Demolition of existing structures and construction of a multi-storey mixed-use development comprising tourist accommodation, commercial office, cafe/restaurant, ancillary car parking, and associated building work.

266 – 270 Pulteney Street, Adelaide

020/A066/19

ASSESSMENT REPORT

Figure 5 - Pulteney Street frontage of subject site

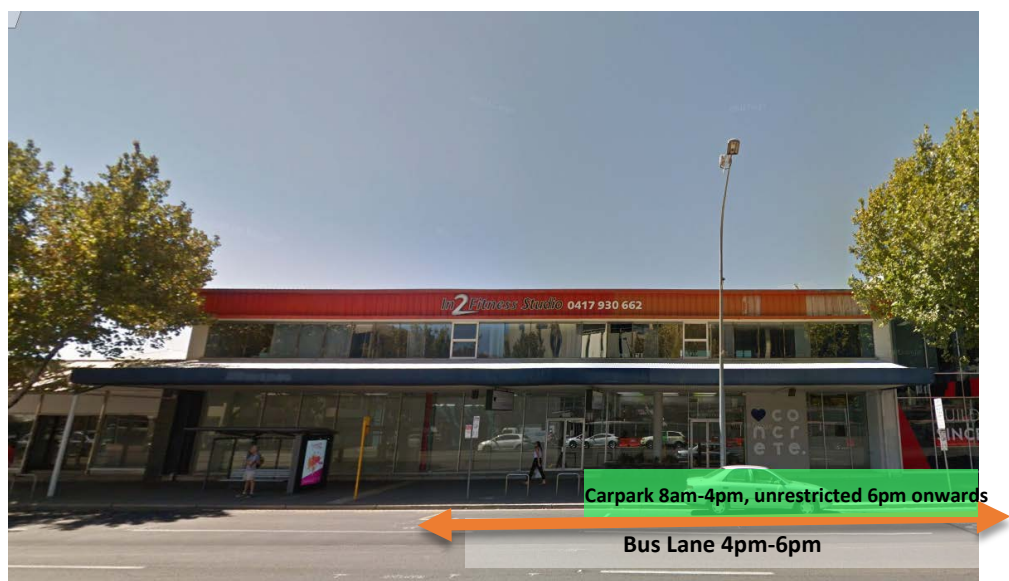
The section of Pulteney Street that the development site fronts onto has several traffic control measures in place for the bus lane. The bus lane operates between the hours of 4pm to 6pm. During the alternative hours of 8am-4pm there are two 15 minute car parks, from 6pm onwards the carparks are unrestricted. There is also a loading zone approximately 20 metres north of the development site and several 2 hour carparks along Pulteney Street. It is also noted that there is a bus stop directly adjacent the northern section of the site frontage.

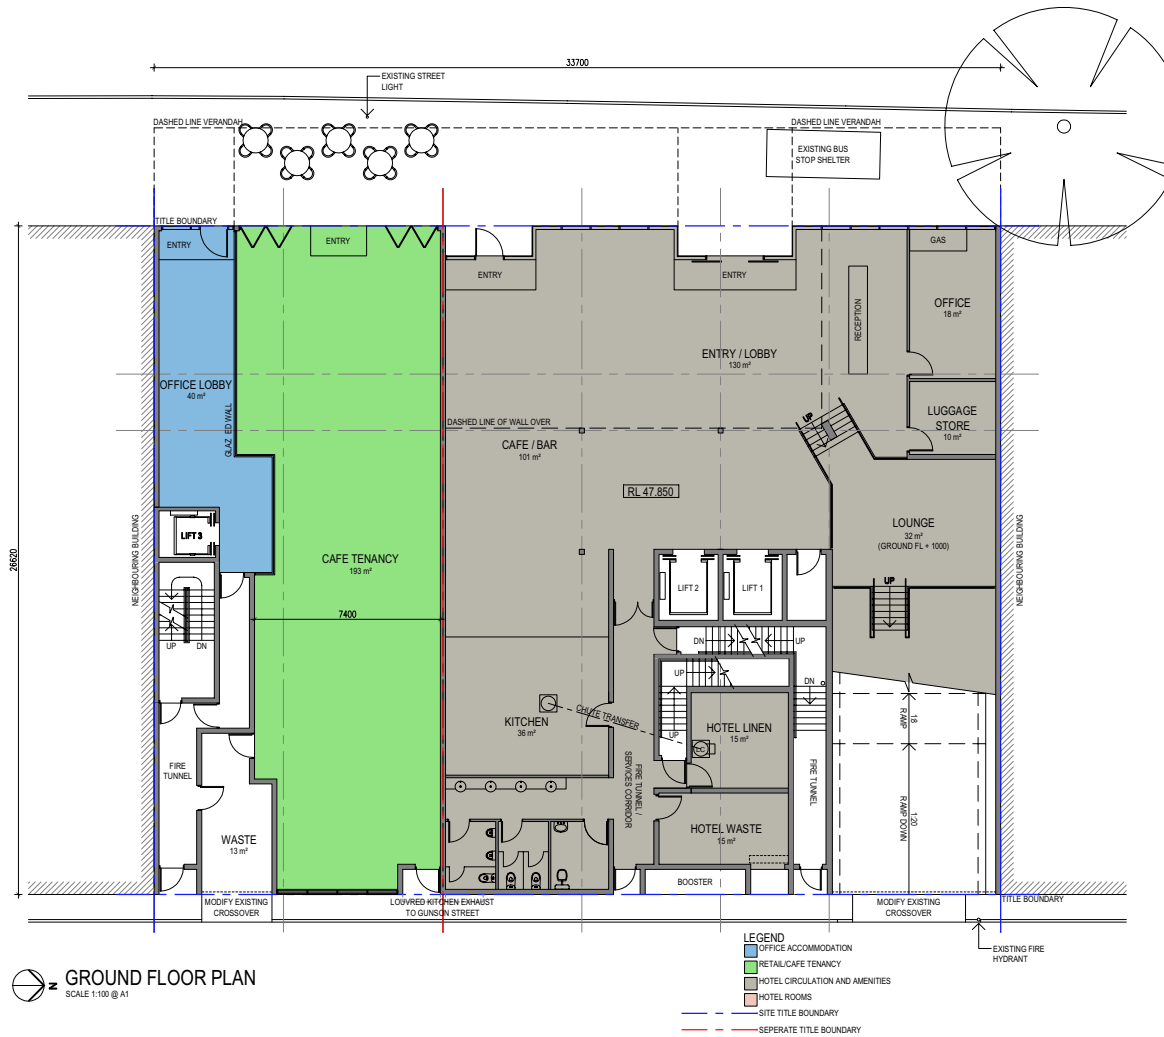
- Modifications are required for the car parking area to meet the requirements of AS2890.1, this is based on the general layout provided and the presence of columns within a dimensionally tight space.
- The representation of the columns appears optimistic in terms of width/size. The amendments to the car park required would result in fewer car parking spaces being provided.
- The stacked small car parking spaces at the end of the blind aisle appears to be unworkable in practice due to manoeuvring requirements.
- The minimum provision of 17 bicycle parking spaces does not appear to be able to be accommodated.
- No end of trip facilities in terms of showers/change rooms are shown.

The applicant acknowledged the minor discrepancy within the basement carpark and noted that a revised car parking layout will be provided prior to development approval, which will address Council's concerns and comply with the relevant Australian Standards. A condition of Planning Consent is recommended to be included in the decision to deal ensure the basement car parking complies with the relevant Australian Standards.

GROUND FLOOR PLAN
1:100 @ A1

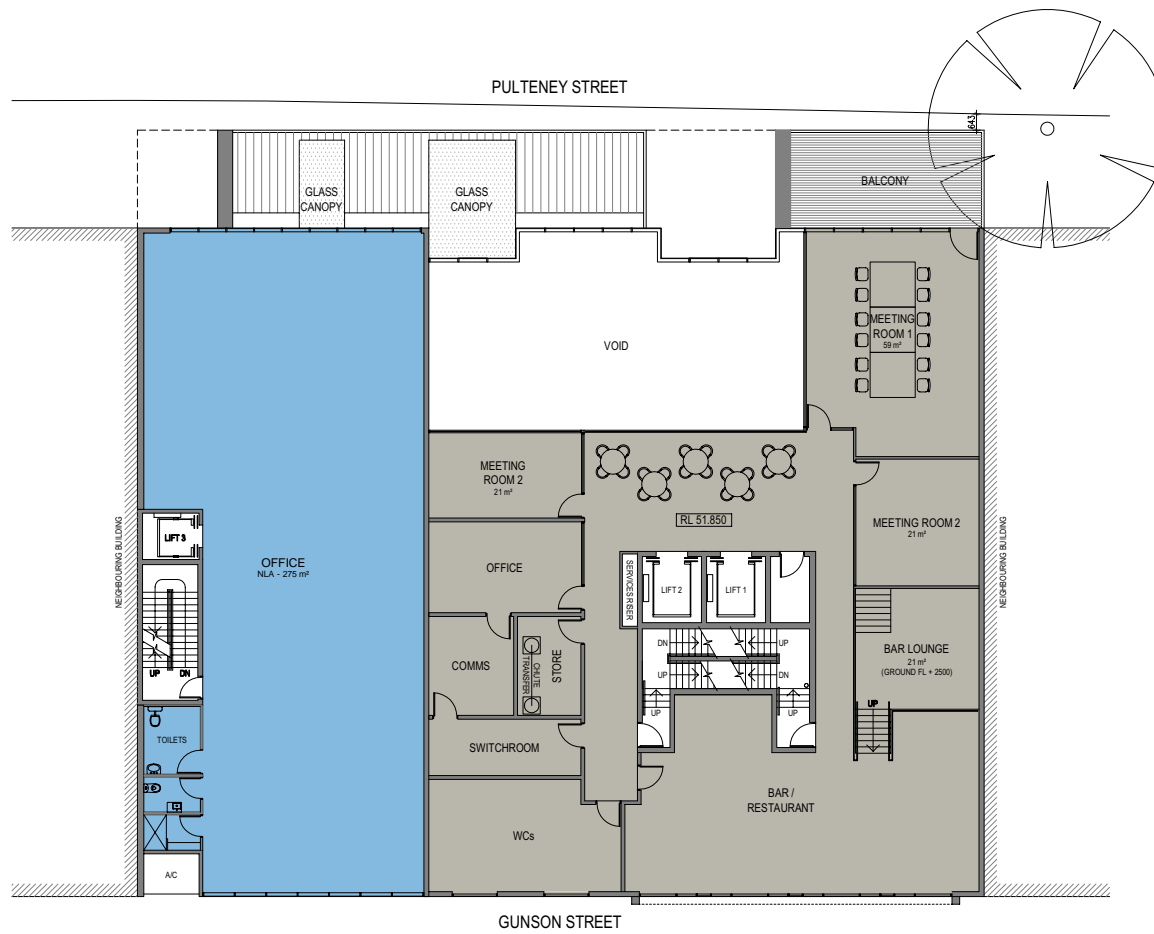
mixed use building through a shared office lobby and cafe tenancy to provide connectivity, and a greater sense of address for the office. The hotel ground floor proposes a cafe/bar and reception to the Pulteney Street frontage which I support. I also support the design intent to maximise the glazing and permeability of this facade. In my view, the detailing of the glazing and services enclosure will be critical to delivery of the design intent for visual permeability. While I also acknowledge the intent to separate the hotel lobby from these spaces, in my view, an opportunity exists to further consider the benefits of a shared lobby space for public, office and hotel guests with the view to maximise the opportunity for genuine activation along the entire main street frontage. The back of house functions including kitchen, hotel linen and waste are proposed to be serviced from Gunston Street. The public bathroom facilities are proposed to the rear of the site adjacent the hotel waste area. I am not convinced the location of the bathroom facilities have been optimised to provide convenient access or a welcoming environment for guests. To that end, I recommend review of the ground floor layout to ensure practical separation of public and back of house spaces and provide convenient access to all bathroom facilities, in particular the accessible bathroom. I am also not convinced by the provision of the raised lounge space that in my view poses accessibility issues.

- Review of the ground floor hotel layout to ensure practical separation of public and back of house spaces and provide convenient access to all bathroom facilities, in particular the accessible bathroom.
